Proposal for amendments to UN GTR No. 8 (Electronic Stability Control)

The text reproduced below was prepared by the expert from the Republic of Korea, proposing to amendments to UN GTR No. 8 (Electronic Stability Control (ESC)). This proposal is based on the Working document (ECE/TRANS/WP.29/GRVA/2020/34) and Informal document (GRVA-07-64).

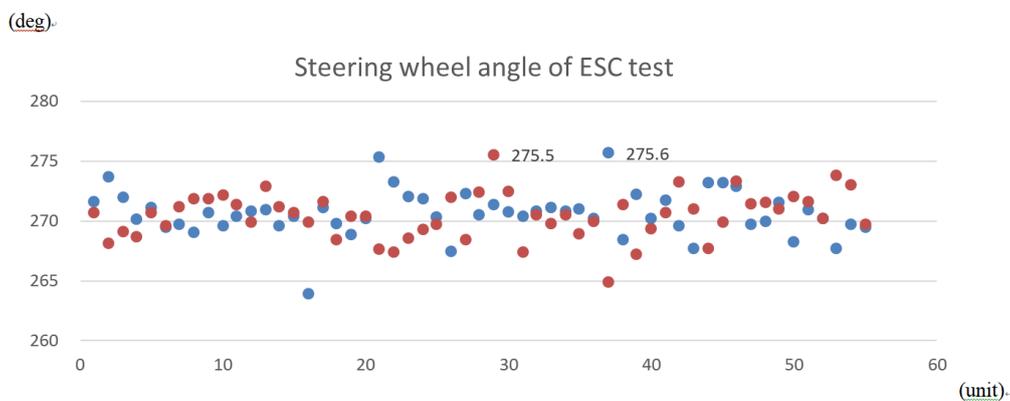
3. For the final angle for the series test which have significantly low steering gear ratio, overshoots are likely to occur. ESC tests of 53 vehicle data show up to 2% overshoots.

4. It could be addressed to a specific use case for ESC test which have significantly low steering gear ratio. It gives the opportunity to adjust the 98 per cent of the maximum operable steering angle only when an overshoot occurs. The overshoot results in excessive moments due to the mechanical limit of steering equipment and causes the steering robot not to complete command input, so the steering robot could stop. Therefore, the final angle should be inputted over 98 per cent of the maximum operable steering angle in order to solve this problem.

If the above calculated steering amplitude of the final run is greater than the maximum operable steering wheel angle determined by design of the steering system, the final angle amplitude for the series test shall be ~~greater than 98 per cent of the maximum operable angle.~~ However if the automated steering machine fails to complete Sine with Dwell Test due to the mechanical limit of steering equipment during the final angle amplitude for the series test, the final angle amplitude for the series test may be greater than 98 per cent of the maximum operable angle.
